AGNICO EAGLE

April 09, 2026

Re: Response to Comments to 2AM-DOH1335 Water Licence Amendment – Operational Update – Information Requests / Completeness Check

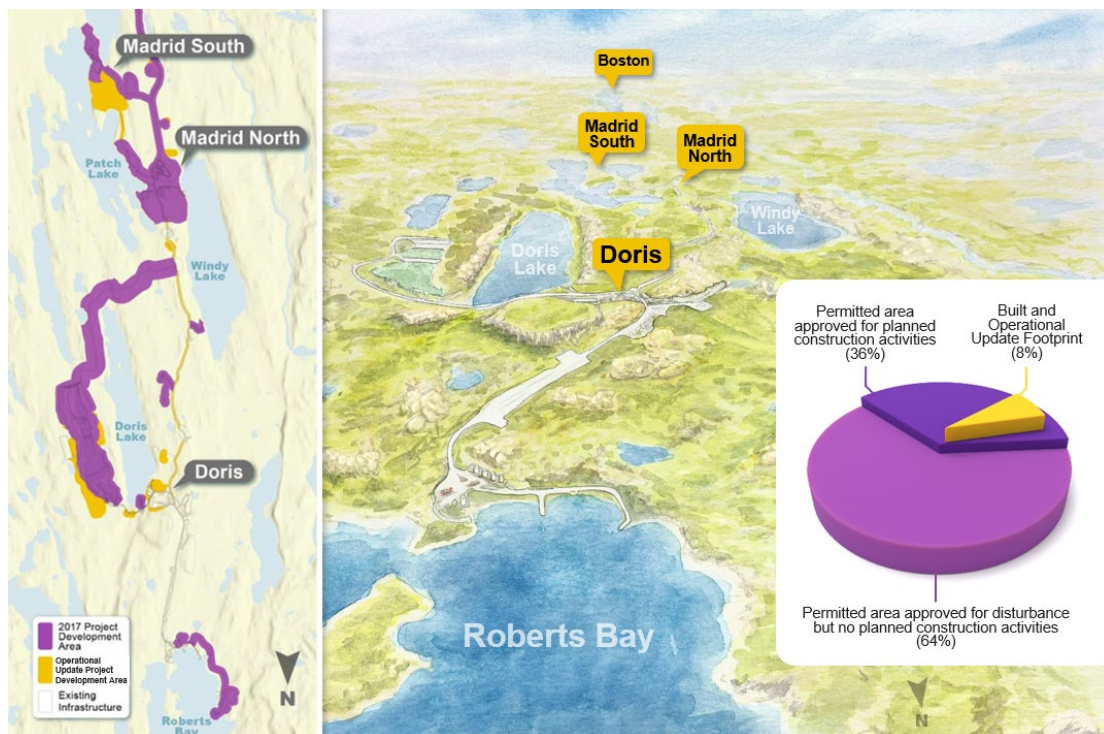
The KIA requests:

- The description of the PDA in section 1.2 be expanded to include the former PDA area and the % increase in the total PDA area due to the proposed project changes.
- Please add a figure showing the former and updated PDA or include a cross reference to an existing figure that shows the PDA

Response to bullet 2)

The following figure was provided to the NPC in their determination of conformity.

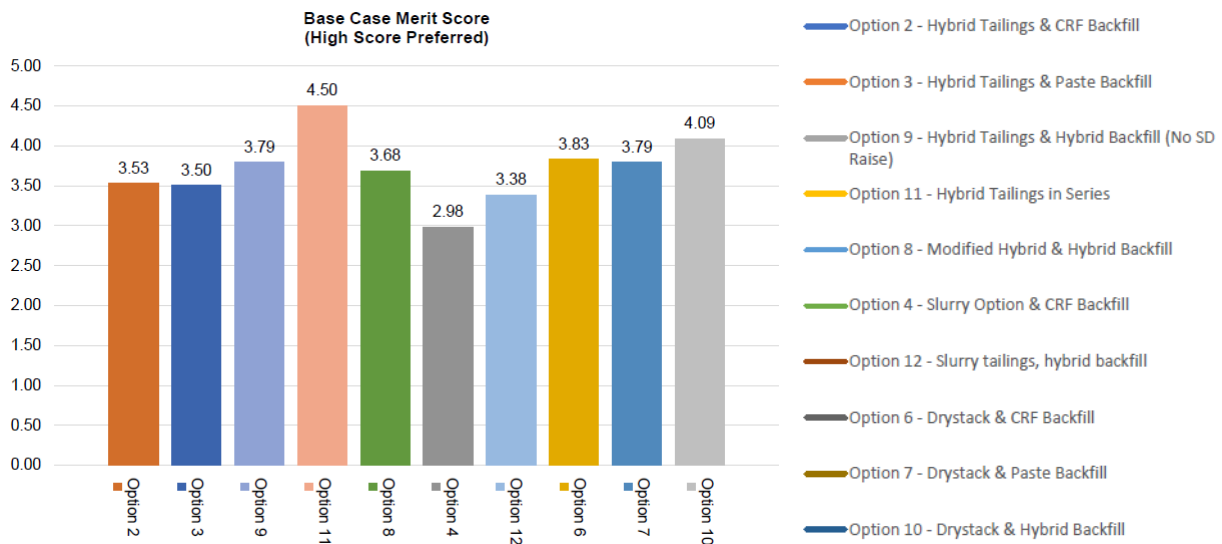
CIRNAC recommends that the Applicant provide the 2024 Multiple Accounts Analysis by SRK as a part of the amended application package.

Agnico Eagle confirms that a Multiple Accounts Analysis (MAA) was completed by SRK in 2024 to evaluate tailings management alternatives for the Hope Bay Project. The outcomes of this assessment informed the selection of the preferred tailings management approach (Option 11) that was submitted as *Appendix 3-A: Tailings Impoundment Area Filtered Tailings Conceptual Design Assessment*. The MAA was completed as an alternatives screening exercise to inform project decision-making, with the results summarized and carried forward into the application documentation prepared for regulatory review. The below summarizes the alternatives considered and the results, with drawings of each option provided in Attachment B.

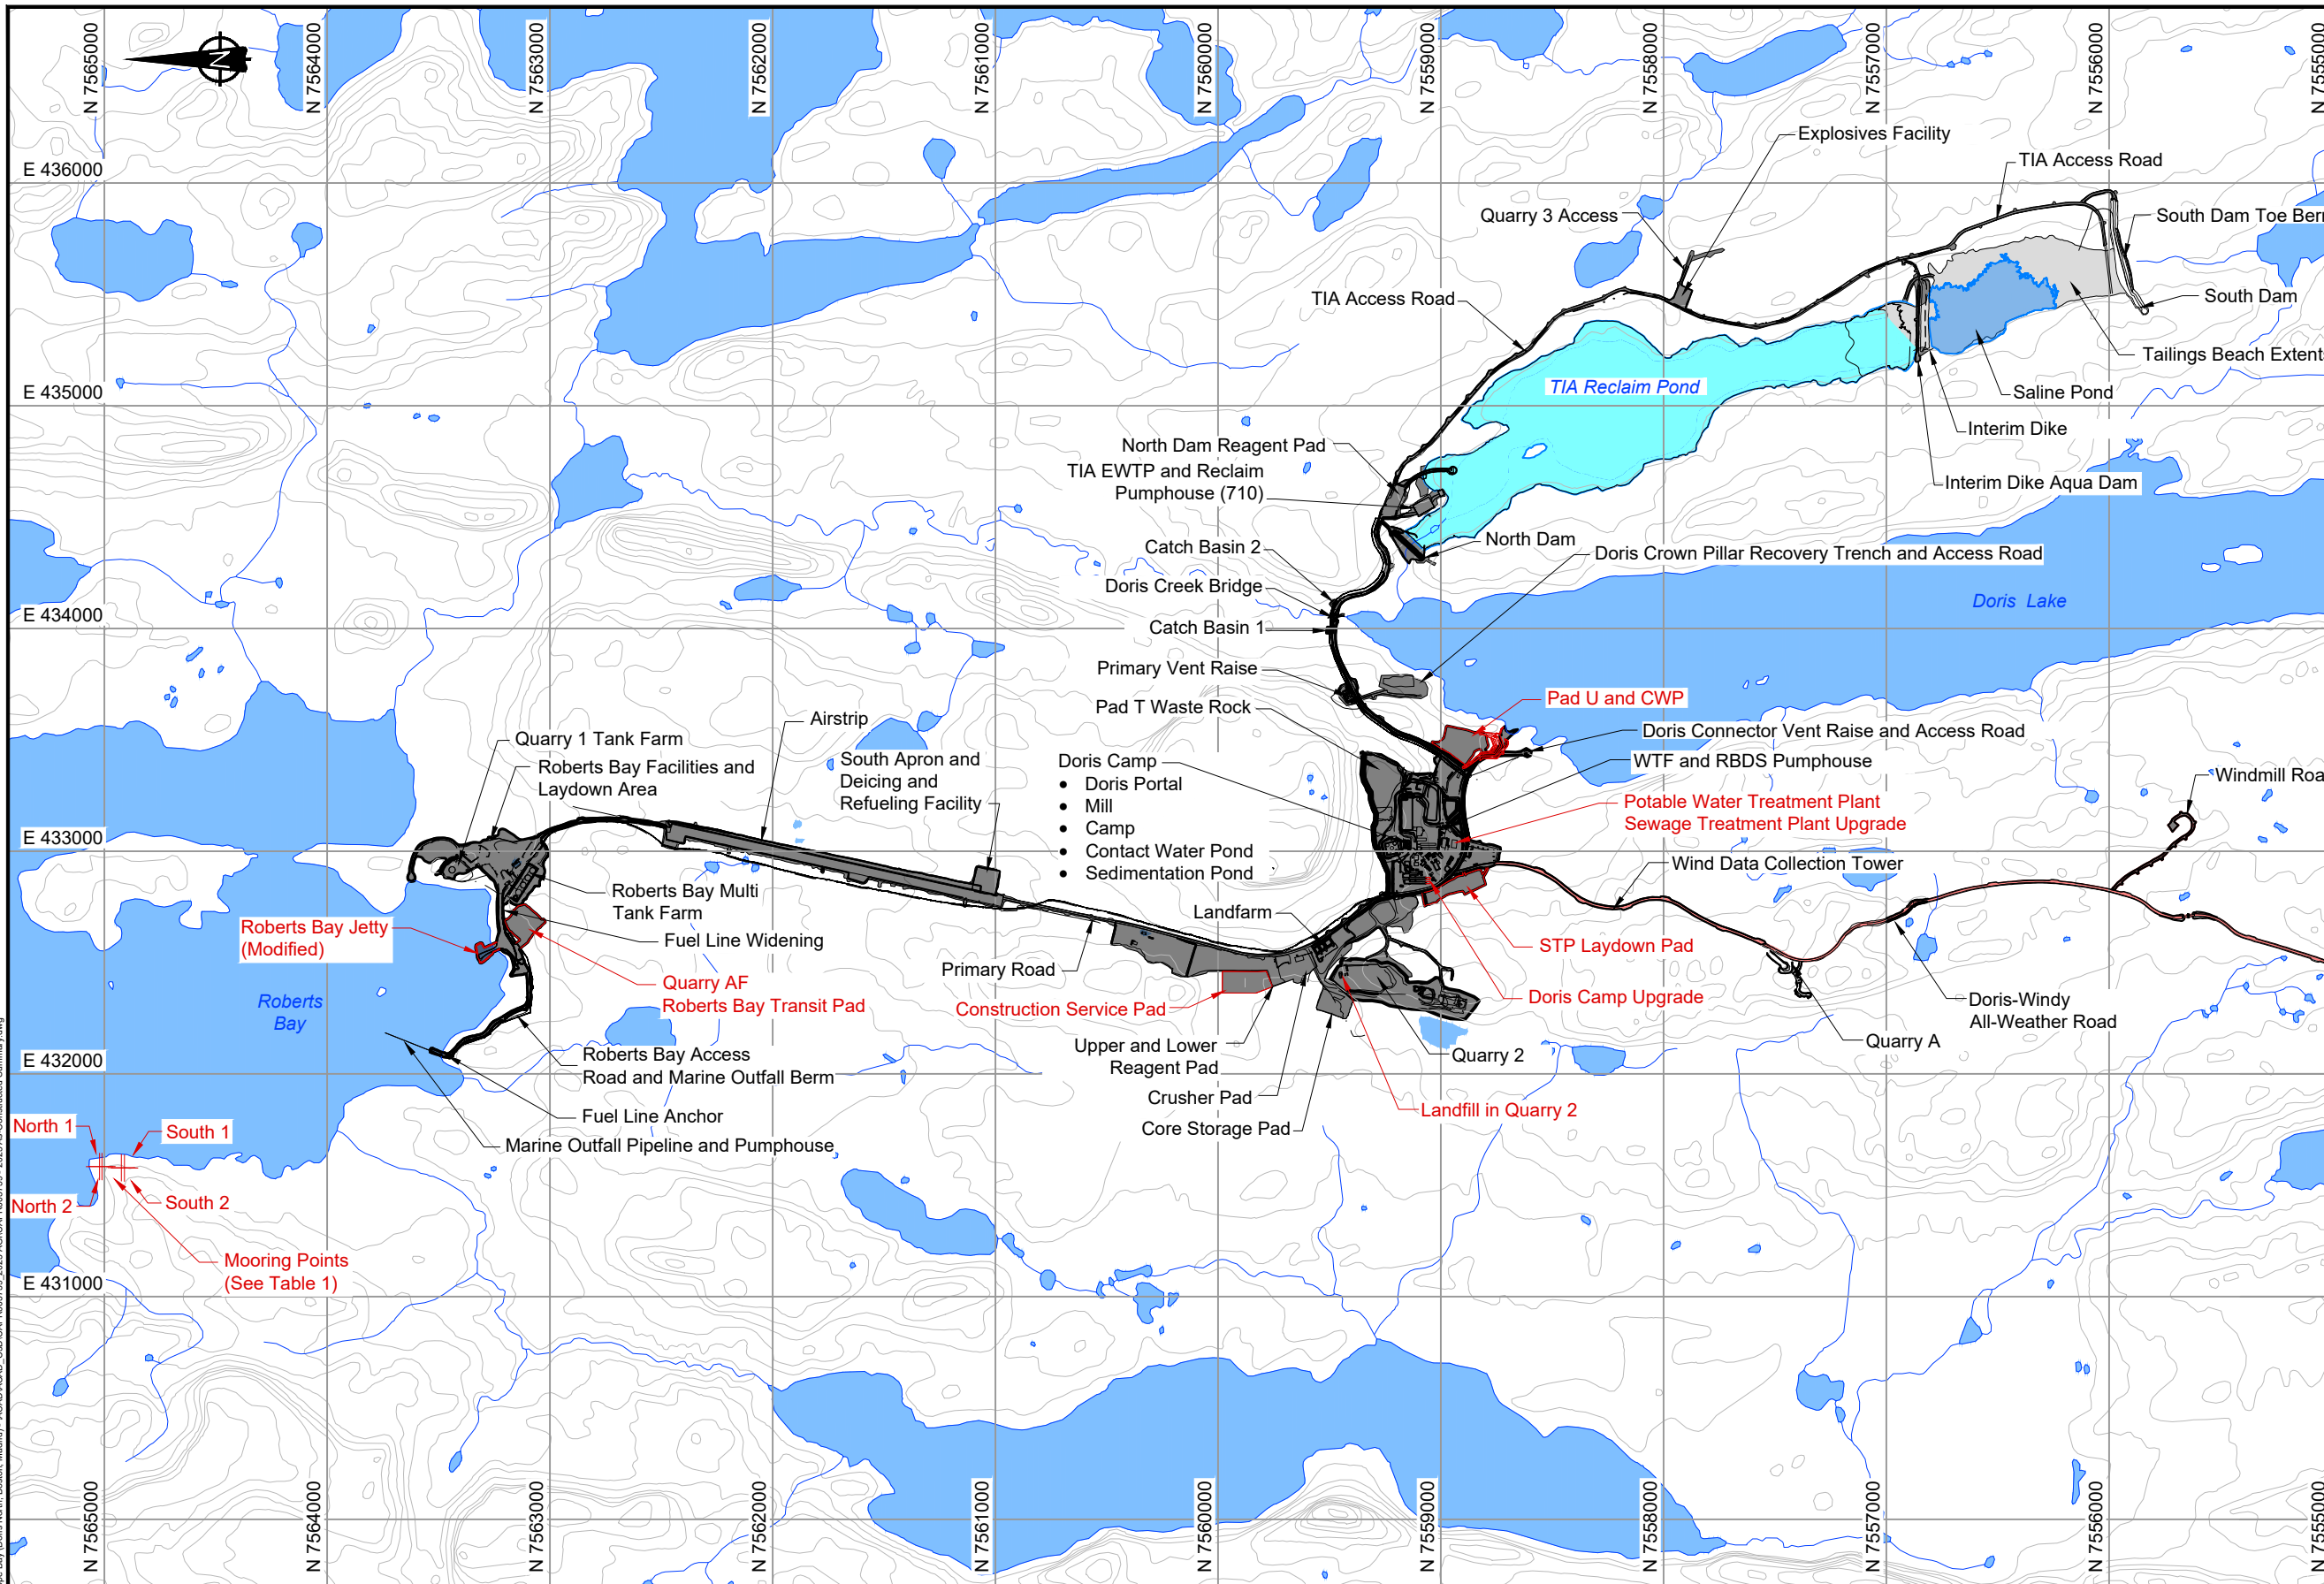
DFO requests the Proponent provide further information on the methods, frequency, and locations of blast monitoring taking place to ensure blast vibrations do not exceed DFO guidelines. Detailed blast monitoring plans should be provided to DFO for review for all blasting activities taking place near fish bearing waters.

For blast monitoring, Hope Bay follows DFO guidelines for blasting and mitigations for fish habitat and does not believe a specific monitoring plan is required.
